EVAcharge SE Errata

chargebyte GmbH

Oct 26, 2023

This document details all known errata for EVAcharge SE.

Figure 1 Location of the missing PLC Transformer

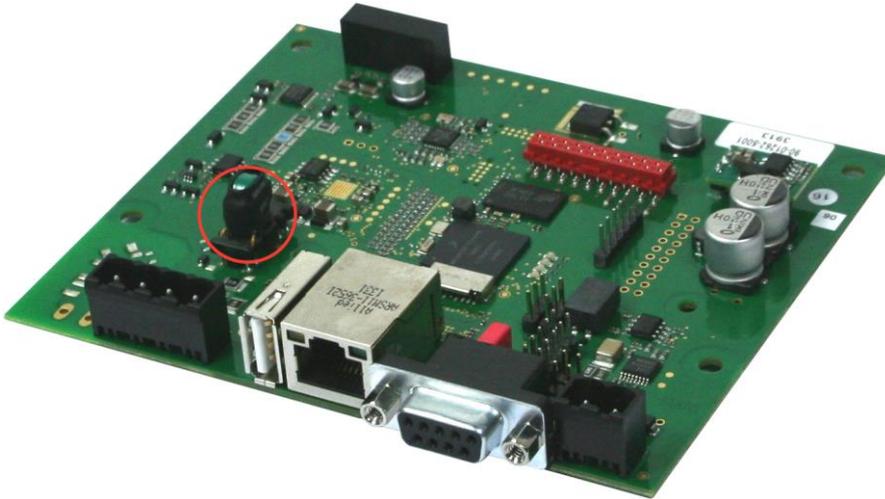
The quality control process of EVAcharge SE allowed that boards without PLC transformer (see red marked component in [figure 1](#)) were tested ok. When finding the error the delivery was stopped immediately - it was possible to determine the total number of defective boards. Two defective boards were delivered to customers.

The Powerline Communication will not work under most conditions, however it is possible that it works partially with a bad performance. SLAC will most probably always fail.

If a board was found, please send this EVAcharge SE back to your reseller or directly to in-tech smart charging. If you are able to solder the component to the board yourself, in-tech smart charging will provide you with the needed transformer immediately free of charge.

Figure 2 EVAcharge SE Bottom Placement for Errata #1, #2 and #3

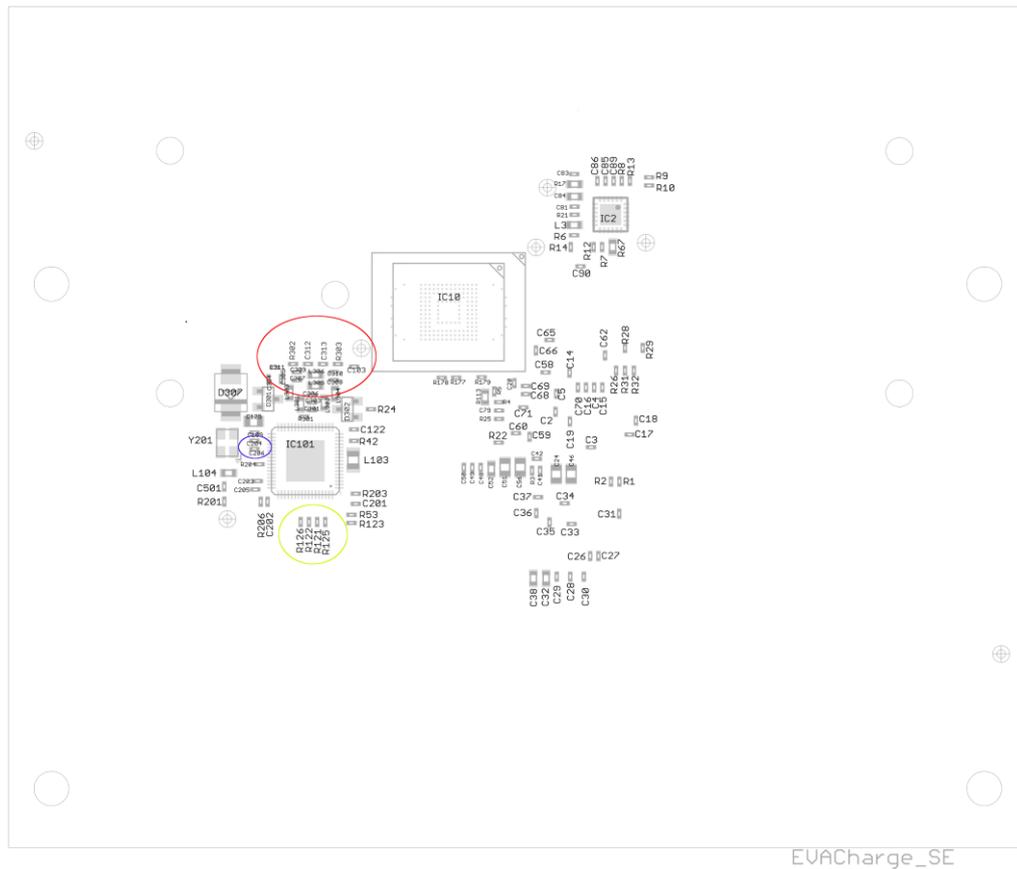
The input attenuation of the powerline signal is too high. This results in bad results when the SLAC process measures the attenuation between EVAcharge SE and a counterpart (e.g. a PEV). Some units were reported to have loss of PLC connection due to this issue.

The SLAC process is not compliant to the applicable standards. The connection losses might cause communication problems while charging.

The HomePlug GreenPHY SLAC is not working with some plug in vehicles (PEVs). This can be tested by enabling SLAC on EVAcharge SE as EVSE and coupling it with a PEV. After the PEV is plugged in (detectable via CP going from static 12V to static 9V) you have to enable 5% dutycycle on CP. After this the PEV should start the SLAC mechanism. Some PEVs do send the SLAC messages but EVAcharge SE will not recognize them correctly.

SLAC messages from PEV to EVSE and vice versa are not recognized and therefore the SLAC mechanism fails. The result is that EVSEs with affected EVAcharge SE devices will not be able to charge the PEV. The reason for the failure is an incorrect reference frequency of the HomePlug Green PHY chip. It needs 25 MHz with a tolerance of 23ppm over all conditions (ageing and temperature drift). This frequency is initially too high due to incorrect load capacitors. The capacitors need to be bigger in order to decrease the reference frequency of the oscillator.

To fully fix this errata two resistors need to be replaced. R302 and R303 have to be replaced by 24.9 Ohm in 0402 - see [figure 2](#), red area.

To fully fix this errata one resistor needs to be removed while another one needs to be added. R126 (10K, 0402) needs to be removed, R122 needs to be populated with 10 kOhm in 0402 - see [figure 2](#), green area.

To fully fix this errata two capacitors need to be replaced. C204 and C206 need to be replaced by 20 pF, package 0402, dielectric: COG/NP0 - see [figure 2](#), blue area.
